BLUE RIVER PLANNING AND ZONING COMMISSION MEETING

TO: Town Manager/Clerk
FROM: Kyle Parag, Plan Reviewer - CAA
DATE: February 28, 2026
RE: Planning/Zoning/Architectural Guidelines review – 271 Gold Nugget

TO: Town Manager/Clerk
FROM: Kyle Parag, Plan Reviewer - CAA
DATE: February 19, 2026
RE: Planning/Zoning/Architectural Guidelines review – 0015 Wilderness

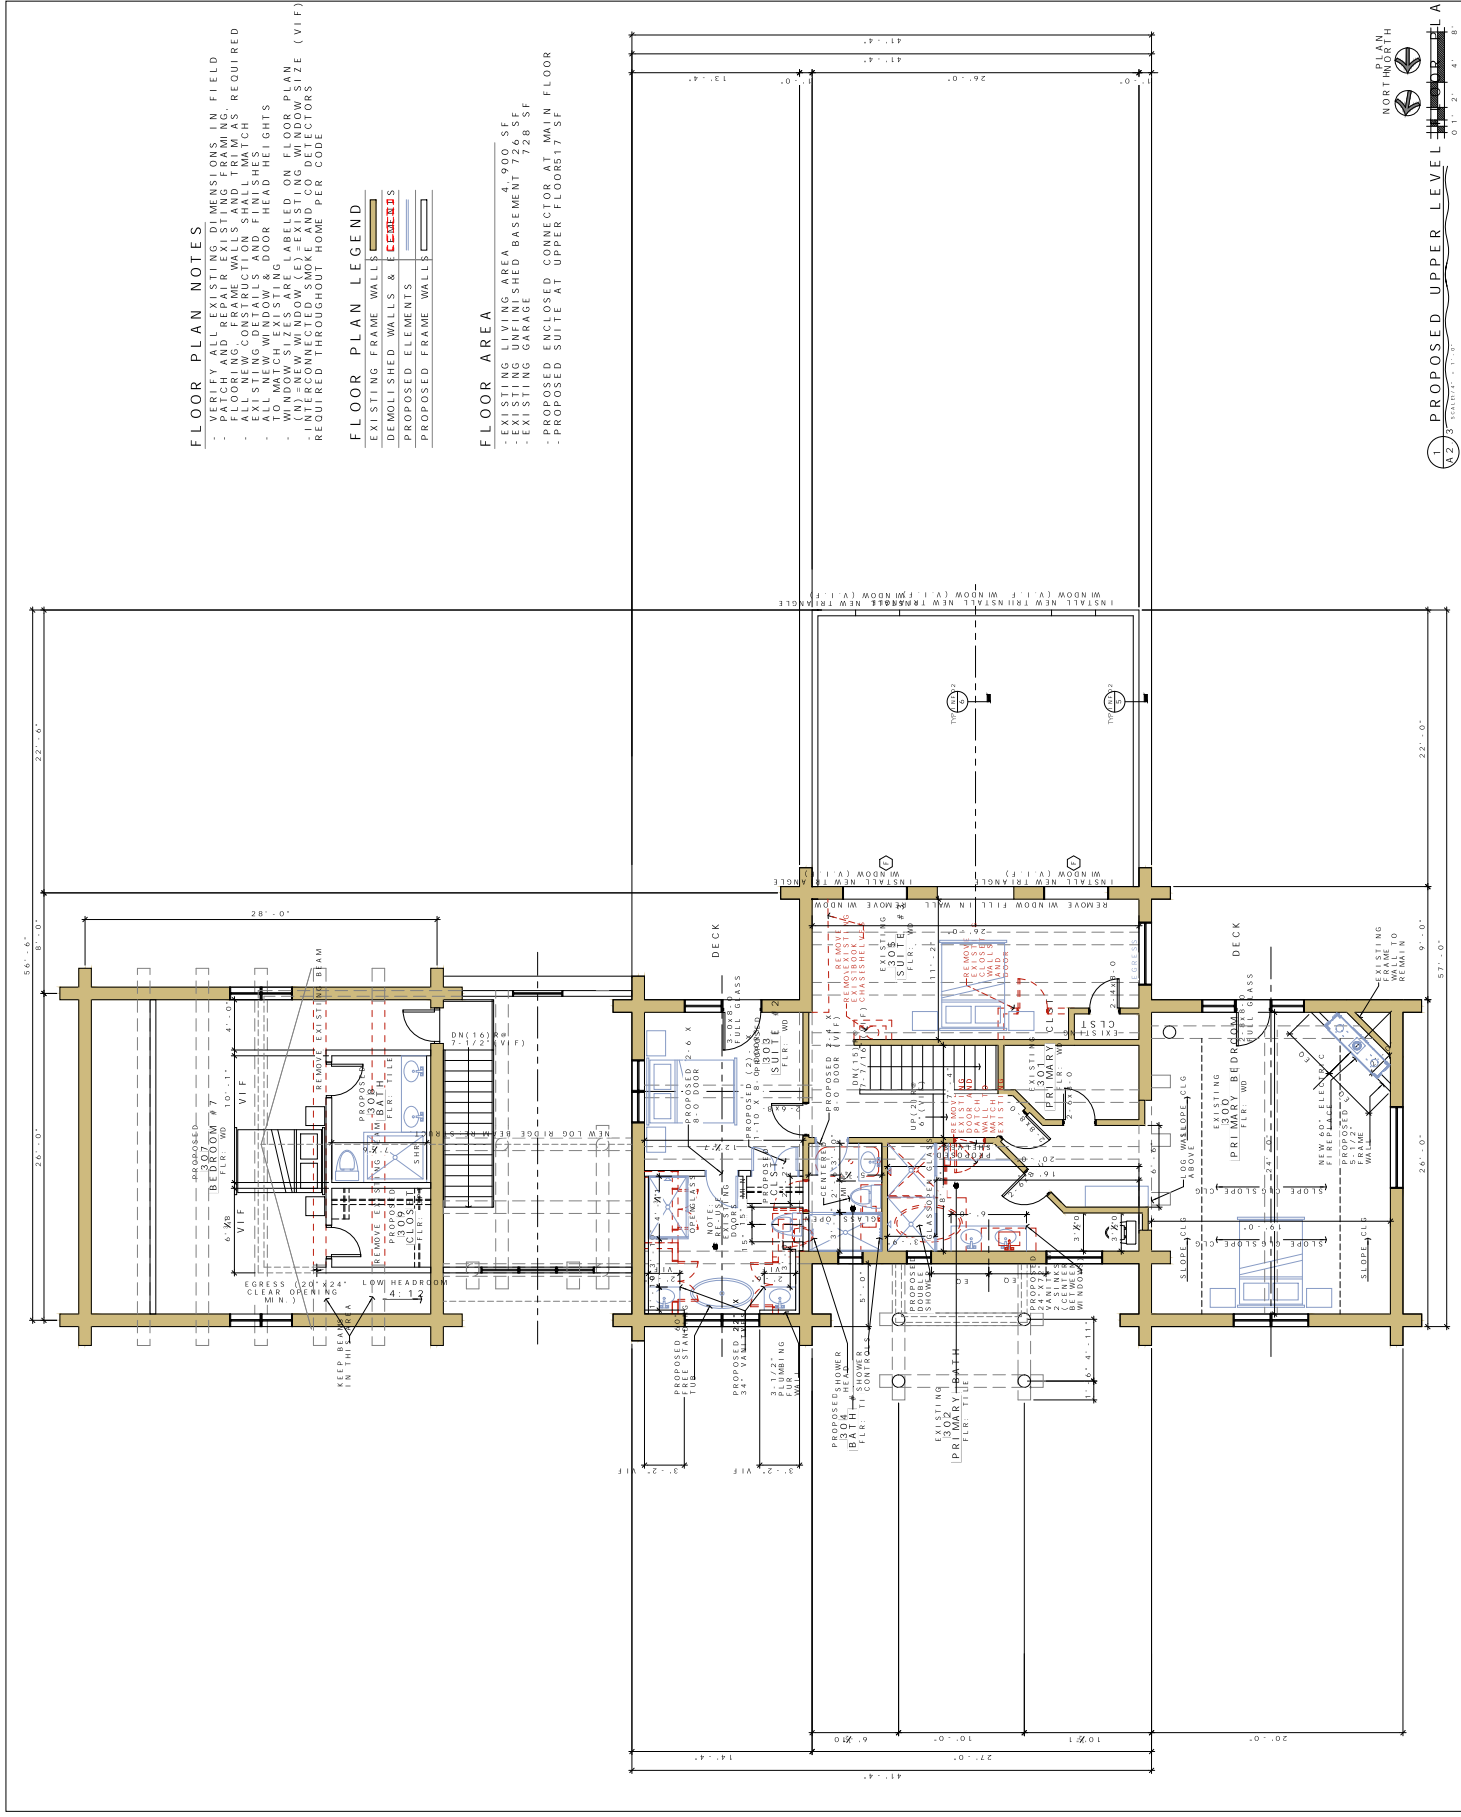
Setbacks: The new deck is not clearly indicated on the site plan, and confusion about the location exists. Several overhead sheets show compliance, but unclear if that indicates the proposed deck layout or not. Requesting the applicant to indicate the extents of the deck.

STANDARD	NOTES/REMARKS	SUBSTANTIAL COMPLIANCE
DEVELOPMENT STANDARD		
Article 3: Easements	Easements are indicated	Y
Article 4: Buildable Area/setbacks	Front setback is measured incorrectly, but does not impact this project. New deck location is unclear.	PC
